PROJECT:  
Lea Castle Farm

TITLE:  
Updated Provisional Requirement for Temporary Soil Attenuation / Mitigation Bunds

REF NO:  
01-LEACF-INQ\_001

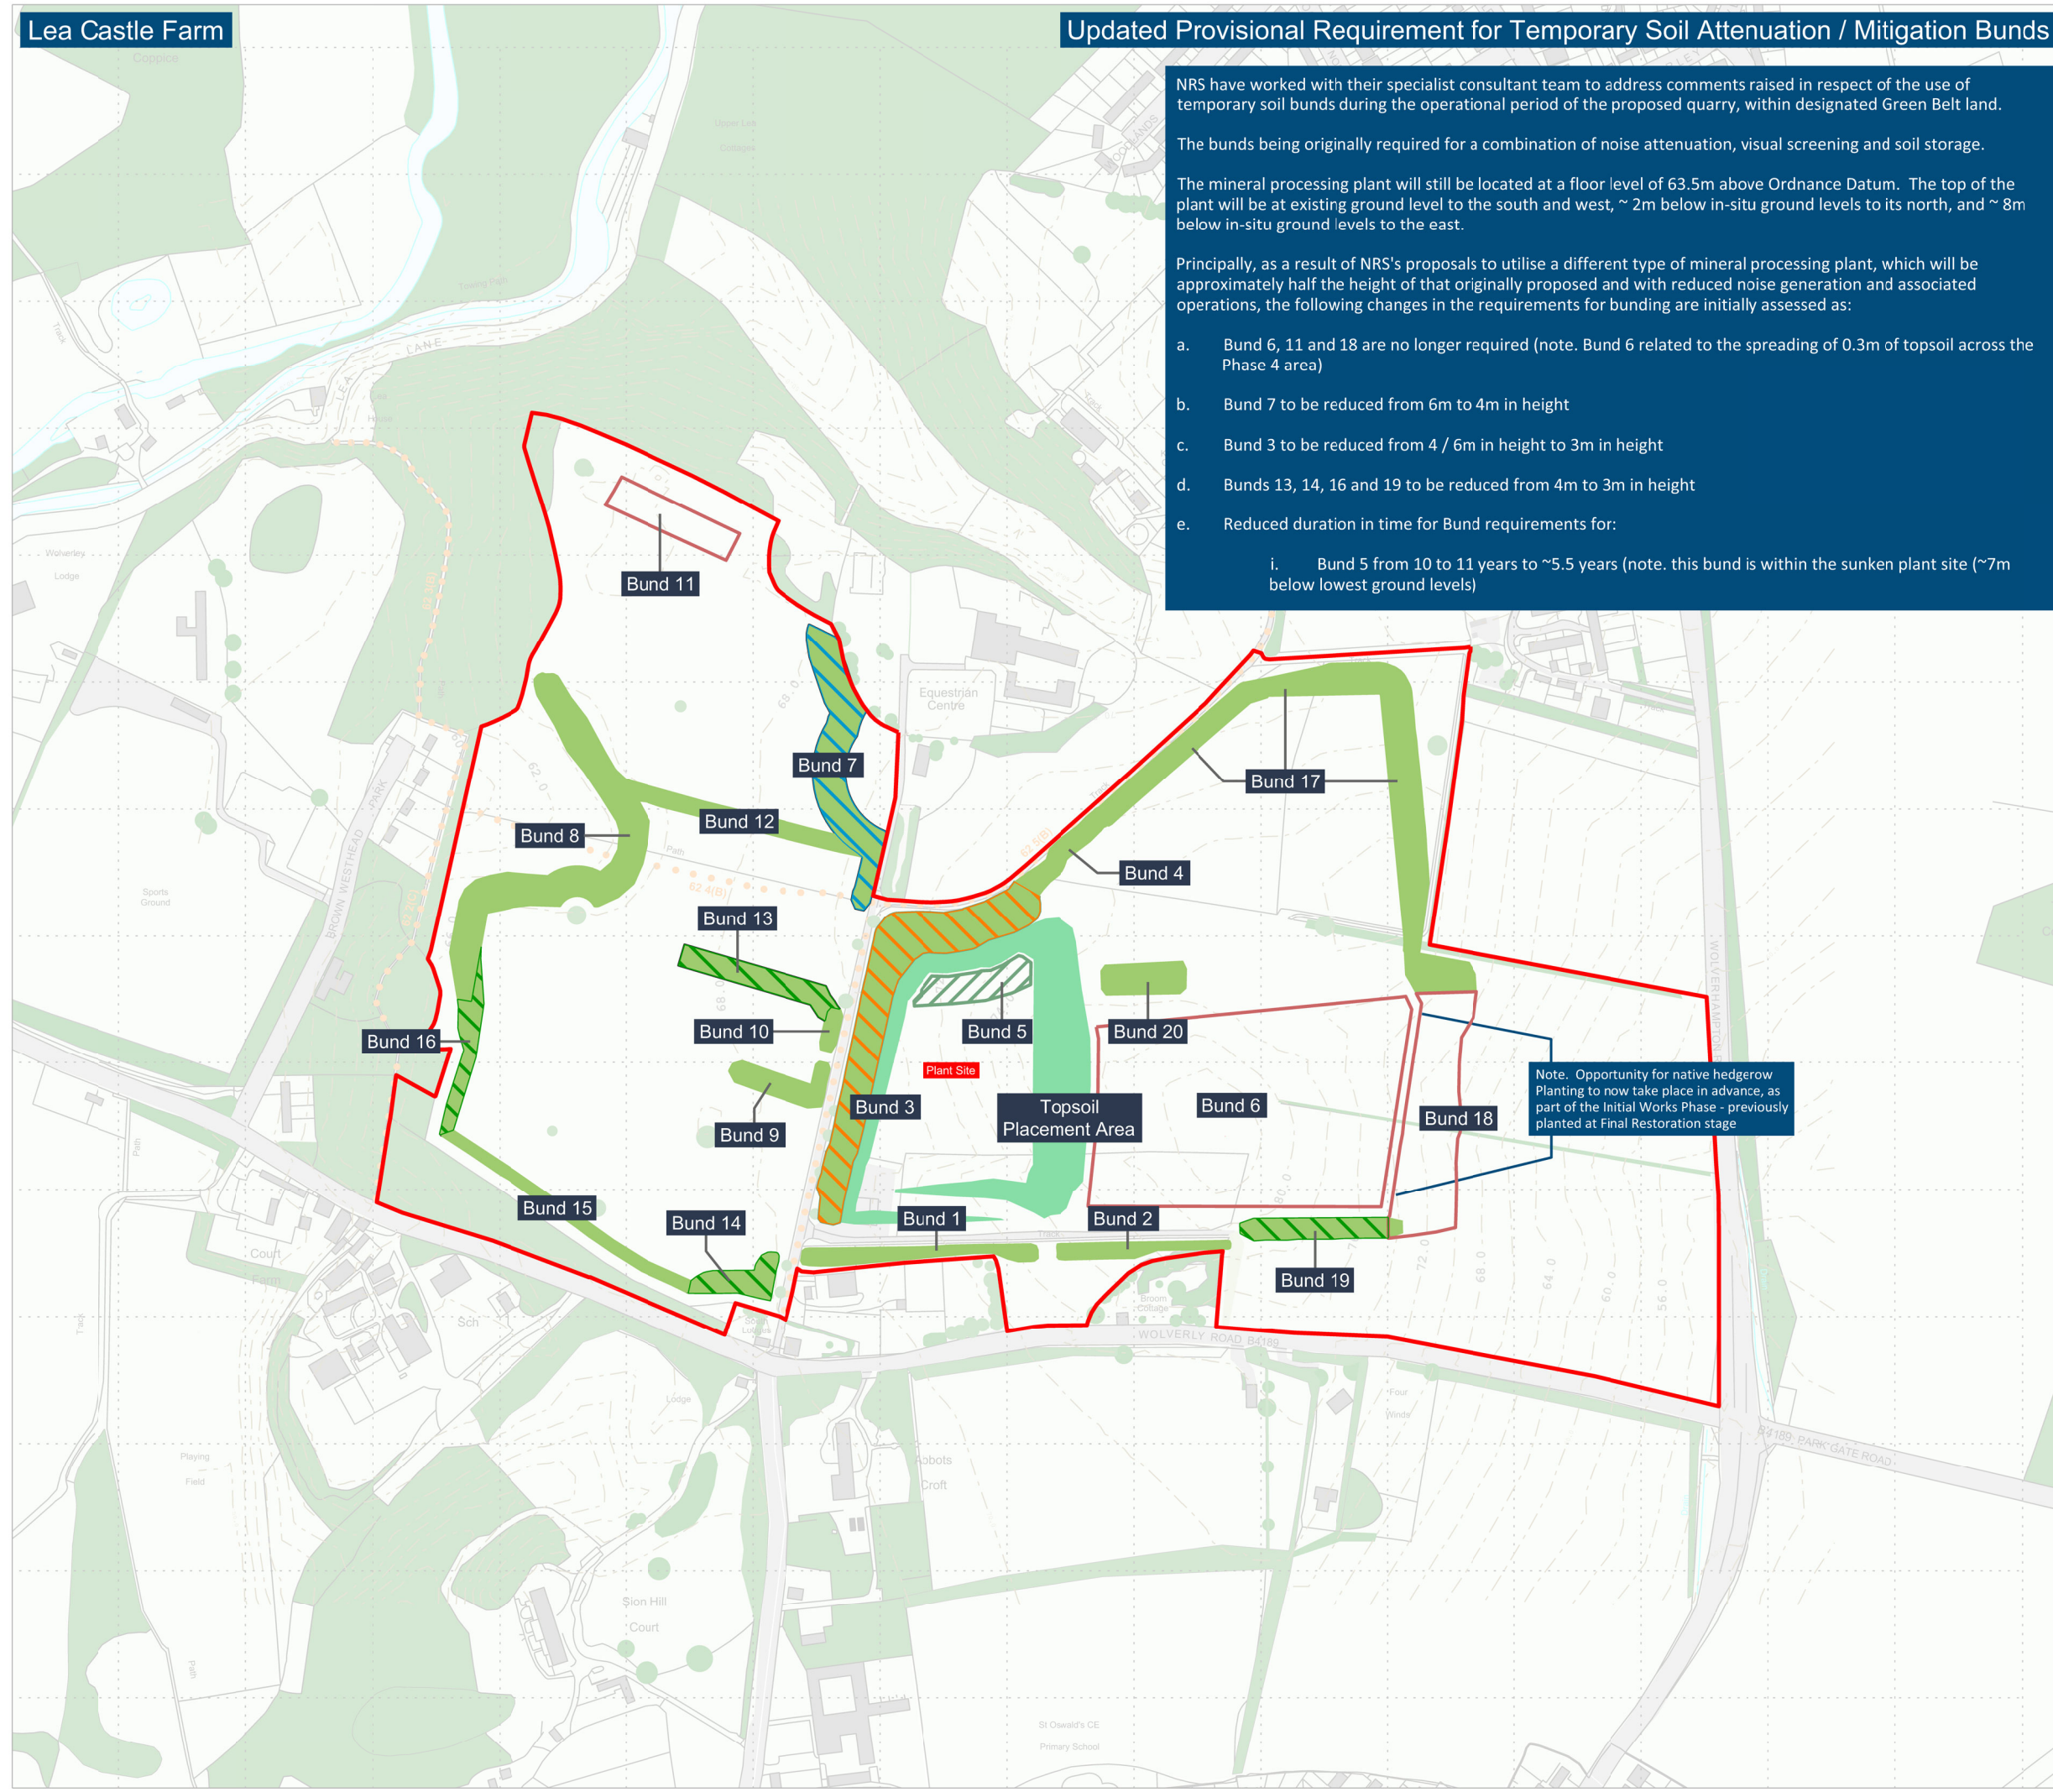
NRS have worked with their specialist consultant team to address comments raised in respect of the use of temporary soil bunds during the operational period of the proposed quarry, within designated Green Belt land.

Principally, as a result of NRS's proposals to utilise a different type of mineral processing plant, which will be approximately half the height of that originally proposed and with reduced noise generation and associated operations, the following changes in the requirements for bunding are initially assessed as:

- Bund 6, 11 and 18 are no longer required (note. Bund 6 related to the spreading of 0.3m of topsoil across the Phase 4 area)
- Bund 7 to be reduced from 6m to 4m in height
- Bund 3 to be reduced from 4 / 6m in height to 3m in height
- Bunds 13, 14, 16 and 19 to be reduced from 4m to 3m in height
- Reduced duration in time for Bund requirements for:
  - Bund 5 from 10 to 11 years to ~5.5 years (note. this bund is within the sunken plant site (~7m below lowest ground levels))

-  Application Boundary
-  New Mineral Processing Plant (6m lower in height and 6 decibels lower than the original proposed plant) - sunken below original ground levels.
-  No requirement for soil bunds for noise attenuation
-  Bund 7 reduced from 6m to 4m in height
-  Bund 3 reduced from 4/6m to 3m in height
-  Bunds 13, 14, 16 & 19 reduced from 4m to 3m in height
-  Reduced duration in time for bunds  
Bund 5 from ~10 to 11 years to ~5.5 year
-  Temporary Bunds 1, 2, 4, 9, 10, 12, 15, 17, and 20 to remain at originally proposed heights of 3m and Bund 8 to remain at originally proposed height of 5m
-  Topsoil Placement Area to inner Plant Site  
Batter Slopes - to be grass seeded
